UNITED STATES PATENT AND TRADEMARK OFFICE

APPLICATION NO.	FILING DATE	FIRST NAMED INVENTOR	ATTORNEY DOCKET NO.	CONFIRMATION NO.
10/092,382	03/05/2002	Derek I. Finch	58937/131	8455

Office Action Summary

DETAILED ACTION

Figure A: The modified figure corresponds to figure 4 with the flange shown.

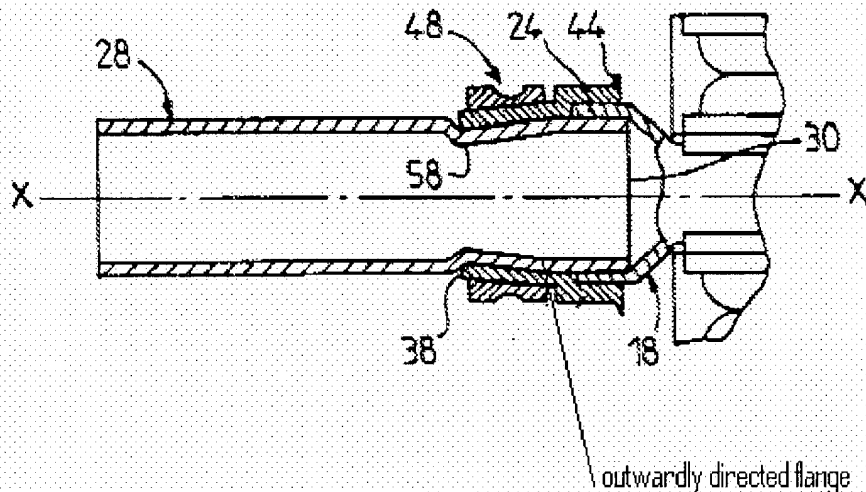
Claims 1,2,15,16,19,24 and 25 are rejected under 35 U.S.C. 102(b) as anticipated by or, in the alternative, under 35 U.S.C. 103(a) as obvious over Chevallier. Chevallier discloses (figures 1,4, figure A as bellow, and column 3, lines 55-57) a heat exchanger comprising a plurality of heat transfer plates (14) stacked together such that a plurality of fluid channels are provided there between the plates (12); at least one connecting grid comprises a pair of plates (20,22) separating the plurality of heat transfer plates into upper group of heat transfer plate and lower group of heat transfer plate (14), and at least one fluid connector (28) in fluid communication with a fluid channel via the connecting grid (18,20,22); the connector (28) comprising a tubular body having an outwardly directed flange formed integrally from a wall of the tubular body to form a fluid tight connection with the connecting grid by deforming an end portion of the tubular body. (See Figure A) Chevallier further discloses (figure 1) the connector (28) provides an inlet/outlet connection on one side of the connecting grid externally of the heat exchanger and connected to both plates (20,22) of the connecting grid. As regarding claim 24, Chevallier does not disclose that the nominal diameter to wall thickness ratio of the tubular body is within 20 to 70. Applicant has not disclosed that having this typically range solves any stated problem, or is for any particular purpose or there is any criticality for selecting this range. Moreover, it appears that the fluid connector would perform equally well with the ratio that

shown in Figure 4 of Chevallier. Accordingly, the use of this range is deemed to be a design consideration which fails to patentably distinguish over the prior art of Chevallier. In re Aller, 105 USPQ 233.
